EARTHSCAPE HORTICULTURAL SERVICES

Addendum 5 to Arboricultural Impact Assessment Report Art Gallery of NSW Expansion Project – Sydney Modern [SSD 14_6471].

Project Name
AGNSW Expansion: Sydney Modern Project

Sheet Title
T1118

LD_DA_00-17

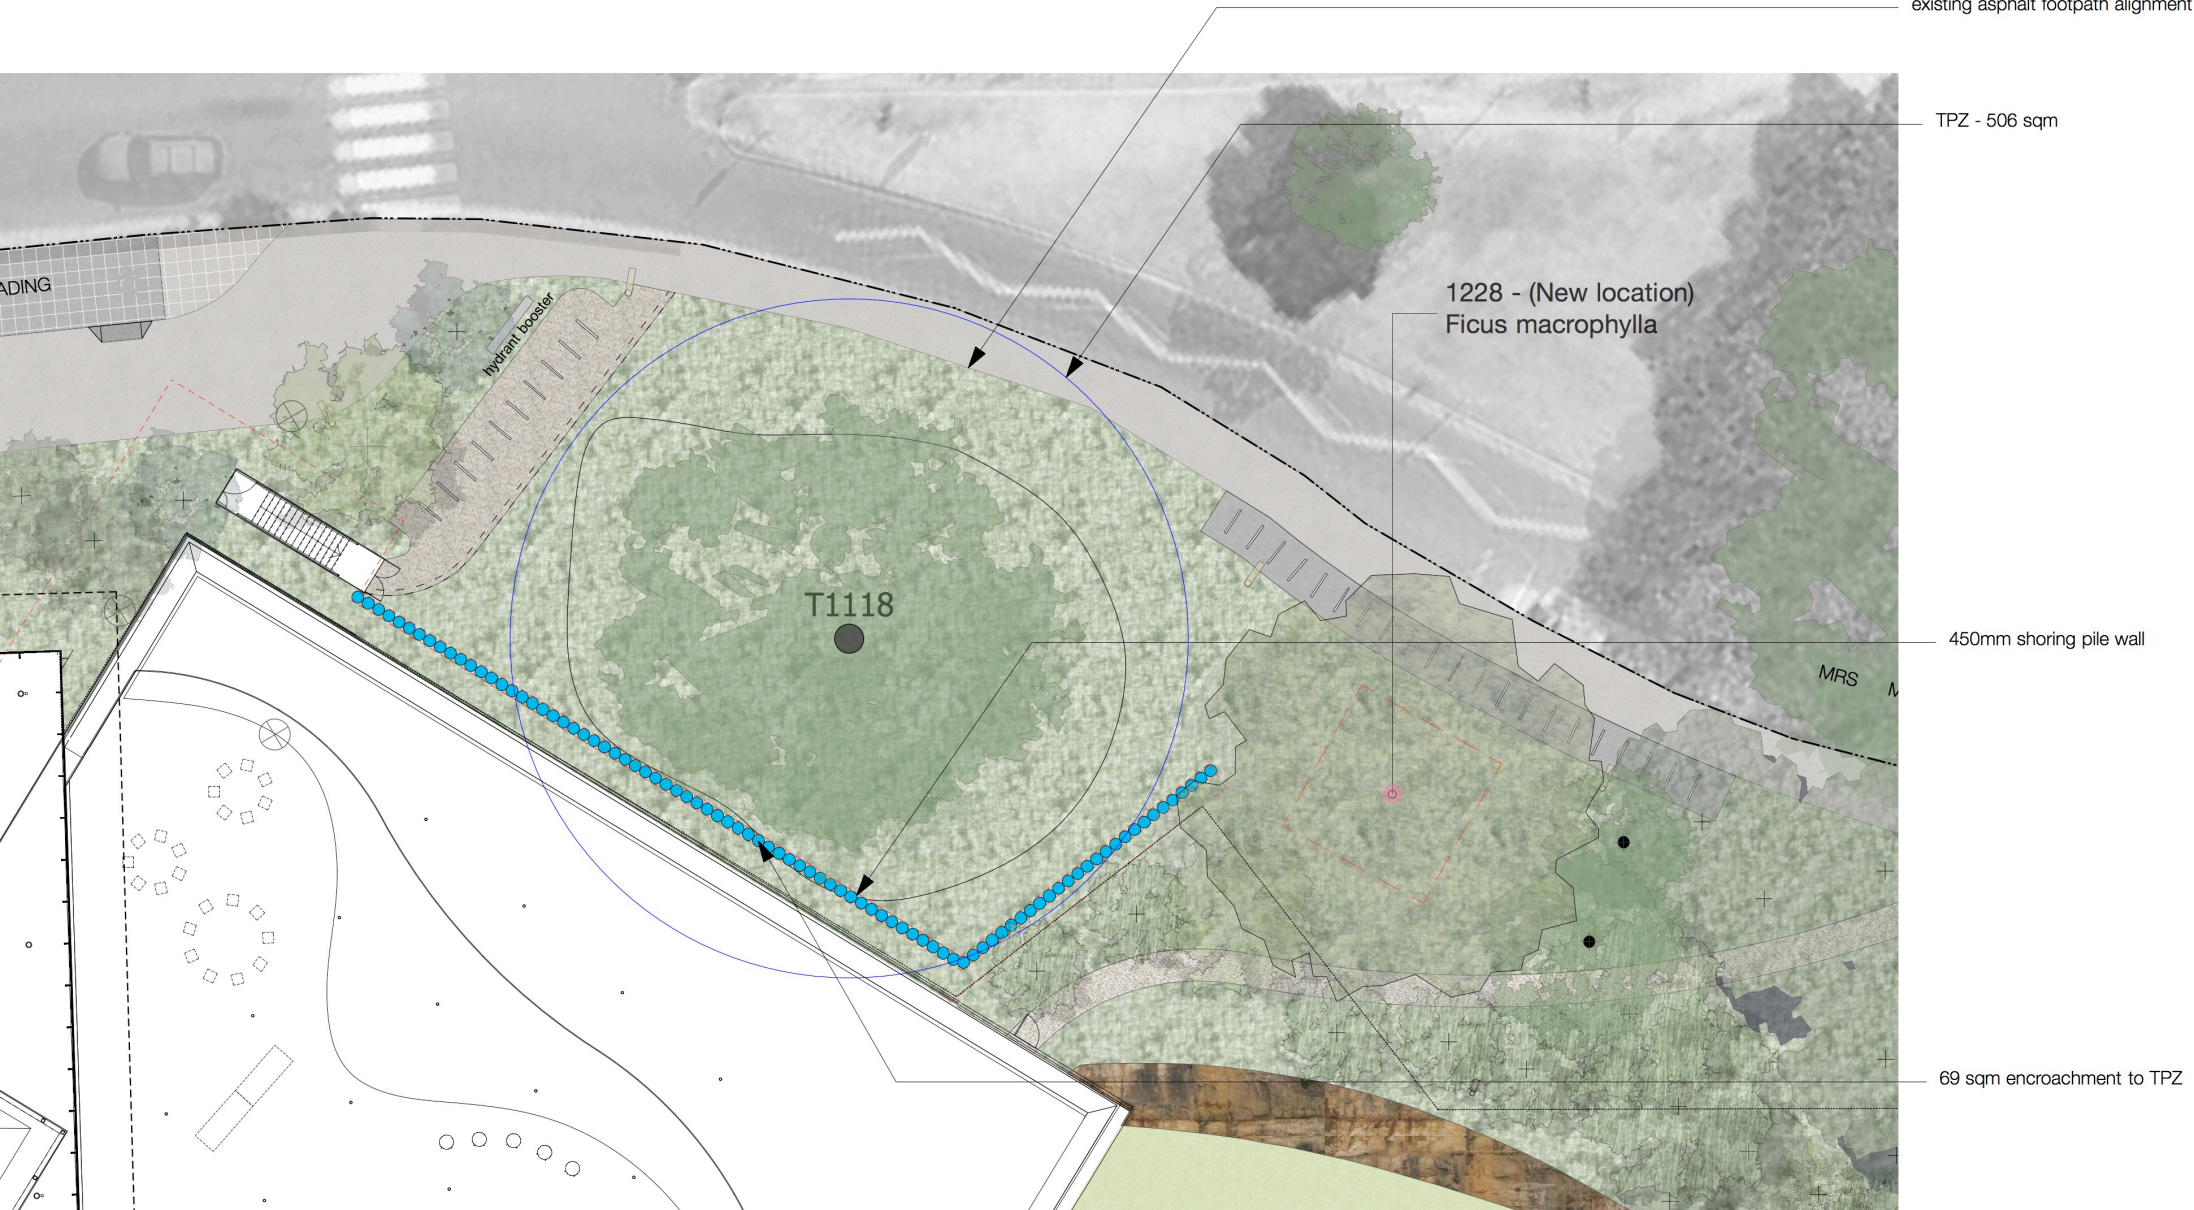
Following preliminary review of the abovementioned drawings by Earthscape, revised drawings have now been prepared by ARUP and McGregor Coxall (Dwg No. LD_DA_00-17 [D] dated 13/08/2018) in an effort to reduce the extent of encroachment (see attached drawing). This has resulted in reduction in the width of the pile wall and the inspection space, reducing the encroachment on the south side of T1118 to just under 14% (based on the Earthscape calculation of the TPZ). The bicycle parking has now been relocated outside the TPZ and the existing asphalt path alongside Art Gallery Road will now be maintained intact at existing levels. As such, there will be no additional encroachment on the north-west side of the tree. Assuming that the calculation of the TPZ by BTC was used (13.56 metres radius), the estimated encroachment from the bulk excavation for the building and pile wall would be approximately 17%.

In my view this species will tolerate an encroachment of 17% of the TPZ, provided that all excavations for the pile wall are undertaken in accordance with Section 10.6 of the abovementioned Arboricultural Impact Assessment Report. It should be noted that ARUP has confirmed that no 'over-excavation' is required for this type of wall construction as assumed by BTC. As such, I confirm that in my view, the proposed revised layout will not result in any adverse impact on T1118.

B	450mm shoring pile	AD	AM	10/8/18
C	Fix 100mm wall as per AP comment	AD		10/8/18
D	Tree 1228 relocated, bike parking moved	AD		13/8/18
